MEMORANDUM

REVIEW TYPE: Preliminary Plan Application

PROJECT NAME: Hillmead – Bradley Hills Lot 100 - 102

CASE NO. 1-03104

Vicinity Map and Neighborhood
Delineation 4

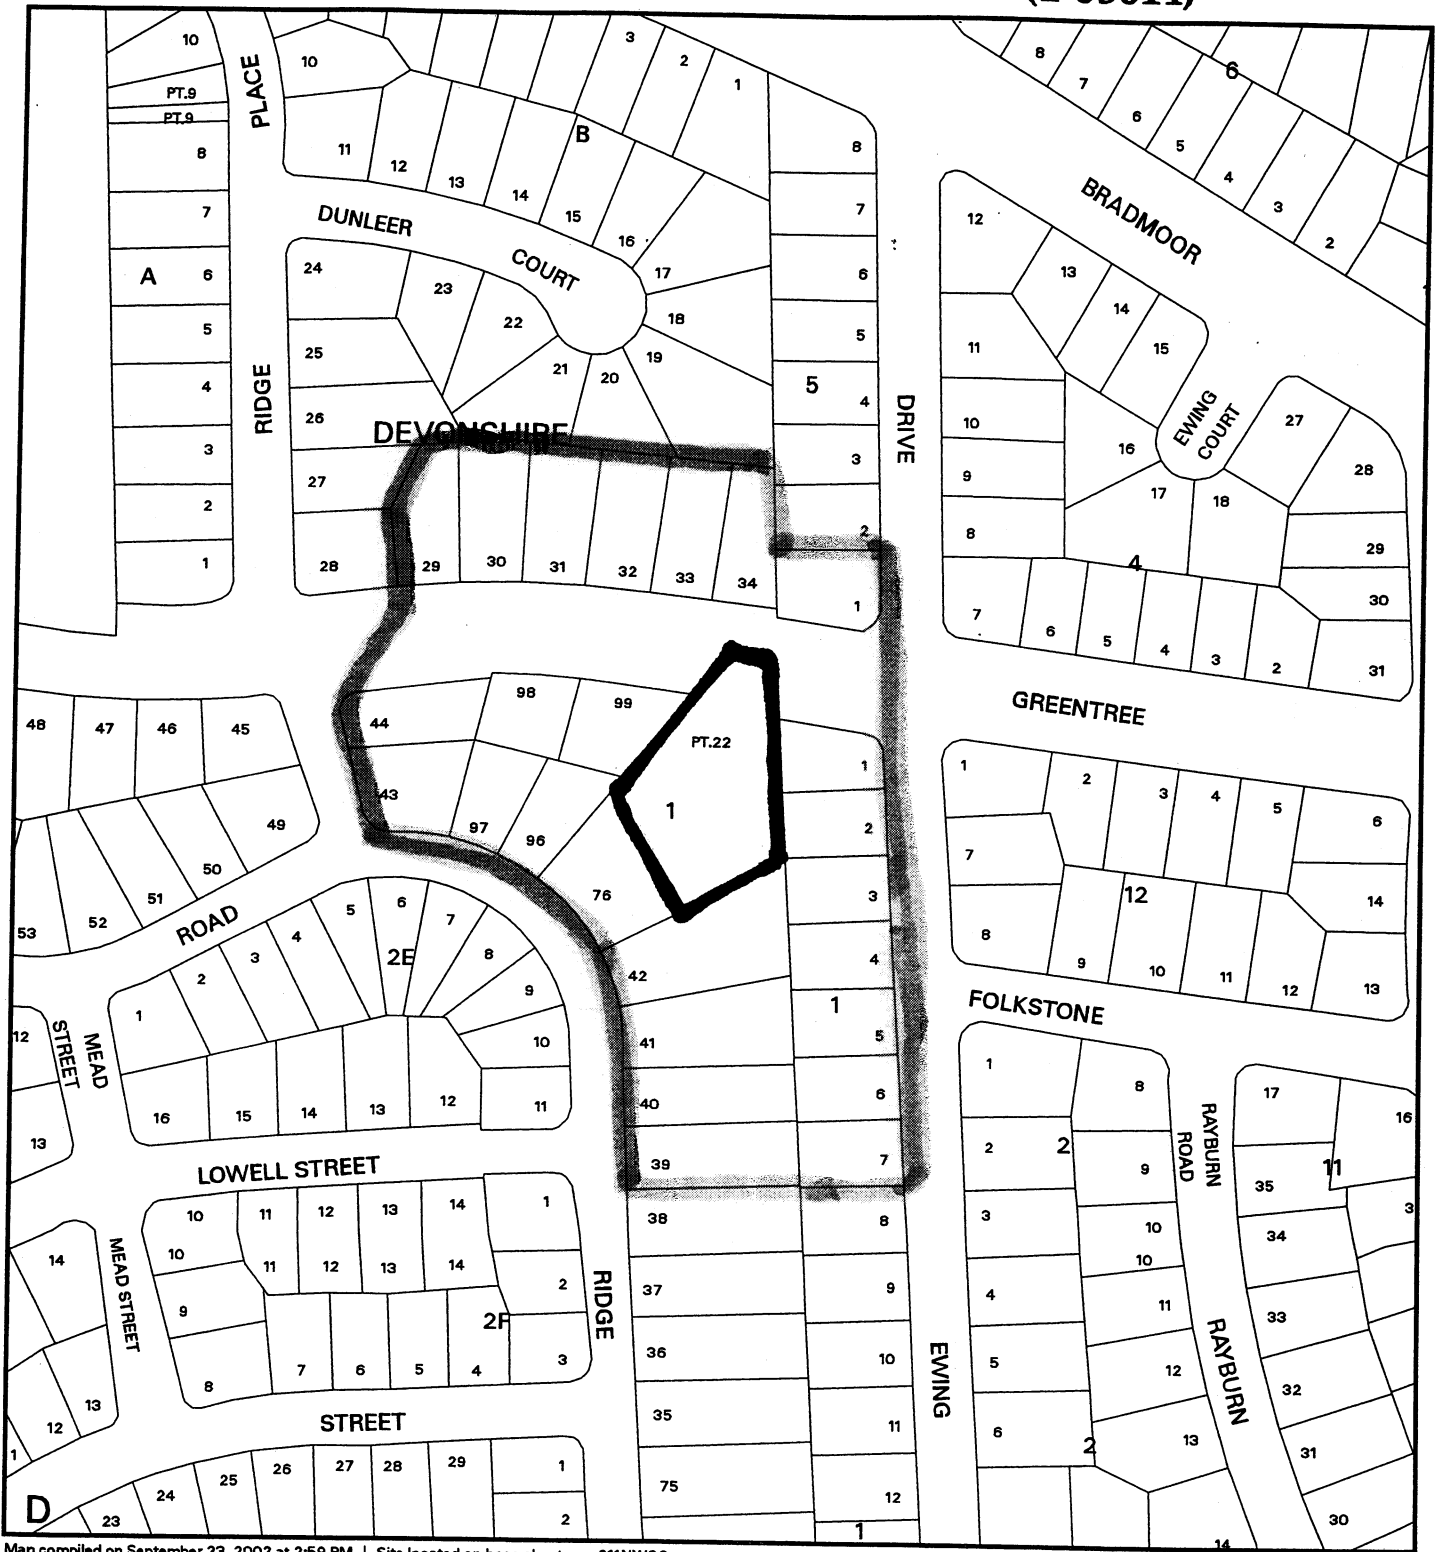
In administering the Resubdivision section, the Planning Board must determine the appropriate “neighborhood” for evaluating the application. In this case, staff has provided a description of the area analyzed under the resubdivision criteria and has also provided an illustration that delineates the neighborhood.

Under the resubdivision criteria the neighborhood used to evaluate the application can only include lots within the same zoning (R-60) classification as the subject property. Staff has also excluded from the analysis any unplatted remainder of resubdivided lots. For the purpose of the reviewing resubdivision criteria staff has identified a neighborhood for this analysis. The neighborhood consists of all the lots abutting the subject property in Block 1 from Ridge Place over to Ewing Drive. Staff did not include the entire area of Block 1 south along Ewing Drive since the whole block extended for such a long distance. Staff chose to “cut-off” the neighborhood boundary in Block 1 opposite to Lowell Street. Staff also included in the analysis area the lots fronting Green Tree Road directly across from the subject site. The neighborhood delineation is depicted on the map attached to this report.

PRELIMINARY PLAN

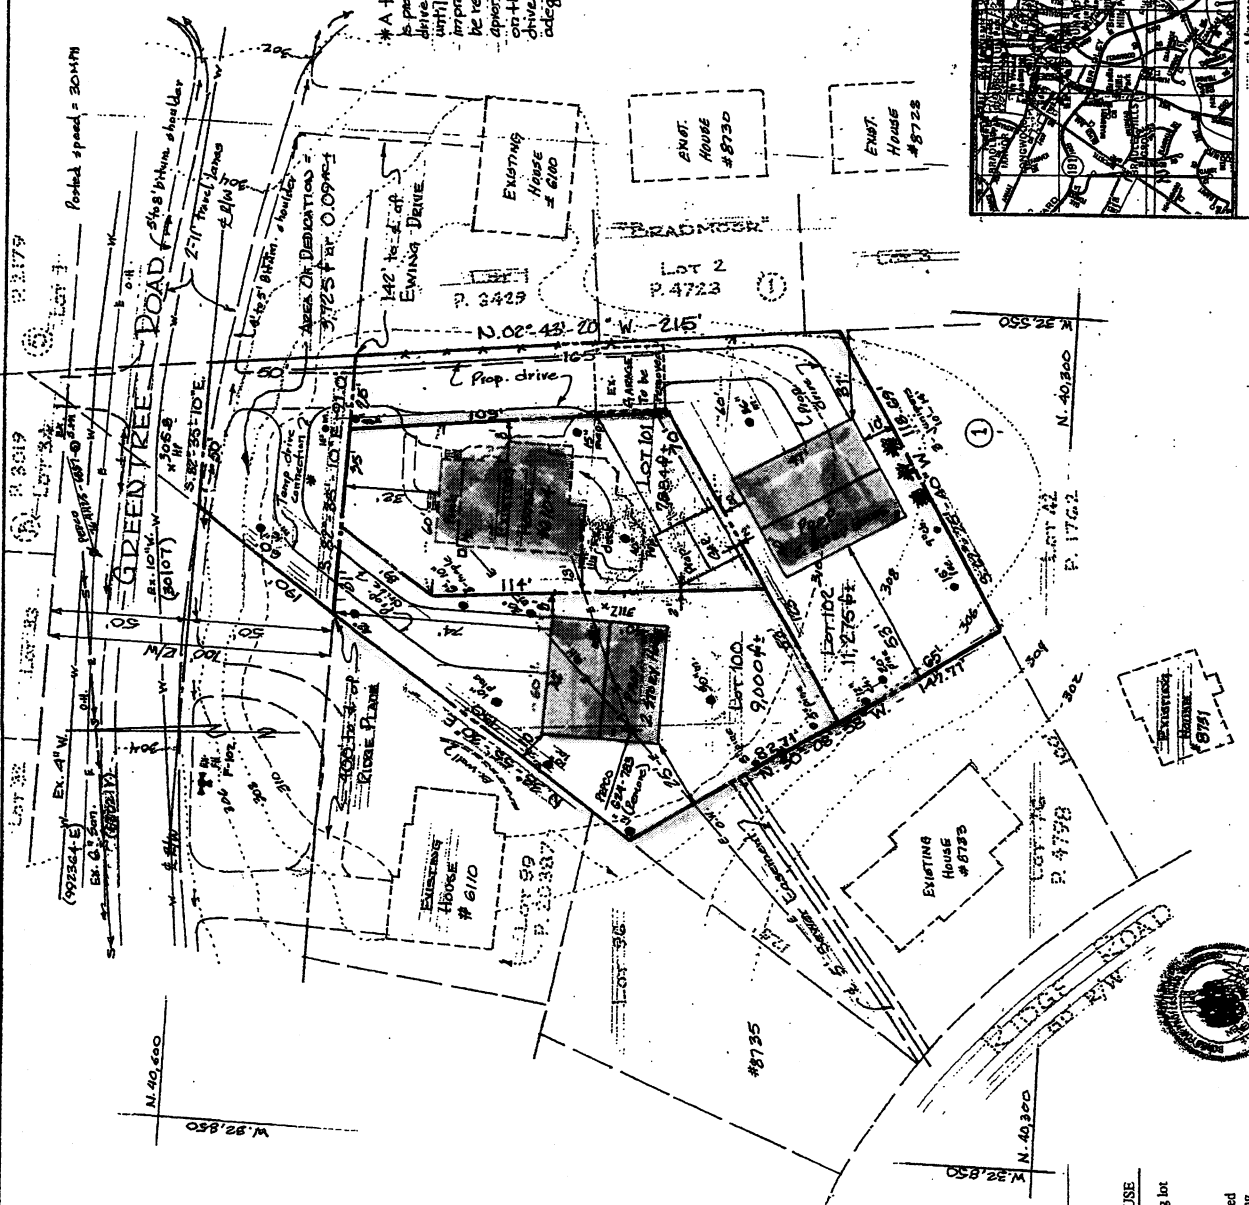
In applying the resubdivision criteria to the analysis area delineated by staff, staff concludes that the proposed resubdivision does not satisfy the criteria set forth in Section 50-29(b)(2) as illustrated by the characteristics set forth in the attached tabular summary. The proposed frontages are considerably smaller than the lots found in the defined neighborhood. The alignment of the two (2) proposed lots is also a factor that must also be evaluated. Alignment refers to correct relative positioning. In subdivisions this means relative positioning of lots as compared to a common feature such as positioning of lot lines that intersect the street line. All of the existing lots in the defined neighborhood have a square alignment. One other characteristic that staff finds problematic is shape. There are no other pipestem configured lots in the analysis area. This application proposes two (2). The majority of the lots in the defined neighborhood are rectangular with the minority being radial.

In conclusion staff does not support the preliminary plan application for three (3) lots based on the provisions under Section 50-29(b)(2)
